FLOOR PLAN: LEVEL P2
DESIGN RESPONSE CONFERENCE- 324 CENTRAL WAY

April 2, 2013
Tony Leavitt
City of Kirkland Planning and Community Development
123 5th Avenue
Kirkland, WA 98033

RE: Departure Request for 324 Central Way, Kirkland WA 98033

DRV12-01513, 324 Central Way

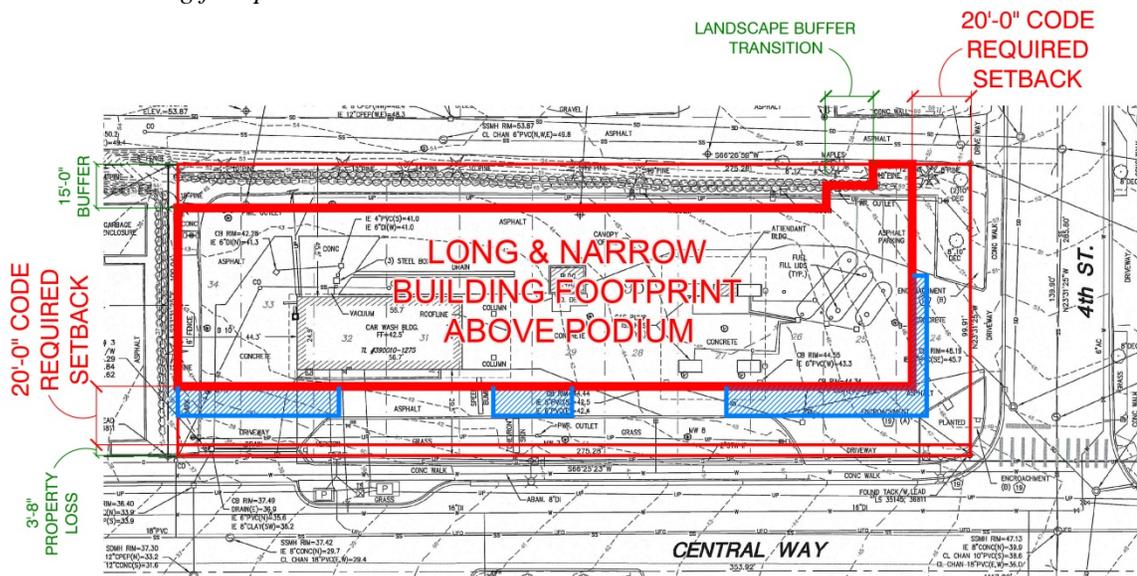
KZC Section 50.47 use zone chart- minimum front yard setback= 20'-0"

Departure Requested

Decrease required front setback from 20'-0" to 10'-0"

- 1.) *Due to Central way street improvement (property loss of 3'-8" along Central way plus 20'-0" required setback by code) on the south side of the property and 15'-0" buffer between commercial and residential zone on the north side of the property, created a long and narrow building footprint.*

2.) *To obtain a balance between the development goals and code requirements, the development team is challenged to address a long single building with shallow modulation and a flat elevation. The code compliant option, due to a long narrow massing, would be out of scale with nearby properties and the surrounding neighborhood. The departure requested option achieves much greater modulation both vertically and horizontally. The resultant building will be much more in keeping with the scale and quality of the surrounding buildings and will clearly achieve a superior design. Ultimately the departure requested option will result in another quality building in downtown Kirkland.*
